Access Compliance Report

Public Rights-of-Way

Intersection ID: 27938	Main Street: PROVIDENCE_COUNTRY_CLUB_DR	Cross Street: SHOAL_CREEK_CT	Location: SE
ADA ID: 1B59C46BB62D	Ramp Type: Perp	Initial Pass/Fail: Fail	Overall Compliance: No
Severity Score: 1.25			
Codes/Mitigation Info/Possible Solution		Field Measurements/Component Compliance

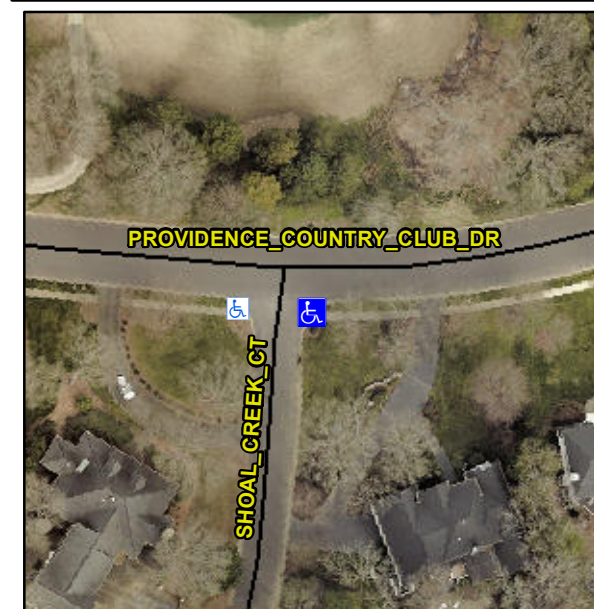
Not Found, R304.5.3

Compliance	Description	Data	Compliance	Description	Data
N/A	Ramp Length (in)	35.0	Yes	Ramp Slope (%)	5.3
Yes	Ramp Width (in)	48.0	No	Ramp XSlope (%)	3.2
N/A	Flare Type LT	N/A	N/A	Flare Type RT	N/A
N/A	Flare Slope LT (%)	N/A	N/A	Flare Slope RT (%)	N/A
N/A	Flare Traversable LT?	N/A	N/A	Flare Traversable RT?	N/A
N/A	Landing Length (in)	N/A	N/A	DWS Provided?	N/A
N/A	Landing Width (in)	N/A	N/A	DWS Contrast?	N/A
N/A	Landing Slope (%)	N/A	N/A	DWS Length (in)	N/A
N/A	Landing X Slope (%)	N/A	N/A	DWS Full Width?	N/A
N/A	Landing Curb? (Y/N)	N/A	N/A	DWS Offset (in)	N/A
N/A	Shared Landing?	N/A			
N/A	Gutter Ponding?	N/A	N/A	Gutter Slope (%)	N/A
N/A	Gutter Lip Ht (in)	N/A	N/A	Gutter X Slope (%)	N/A
N/A	Painted X Walk1?	No	N/A	Painted X Walk2?	N/A
	X Walk 1 Direction	To W		X Walk 2 Direction	N/A
N/A	X Walk 1 Width (in)	N/A	N/A	X Walk 2 Width (in)	N/A
	X Walk 1 Slope (%)	0.0		X Walk 2 Slope (%)	N/A
	X Walk 1 X Slope (%)	3.1		X Walk 2 X Slope (%)	N/A

Remove & Replace Entire Ramp.
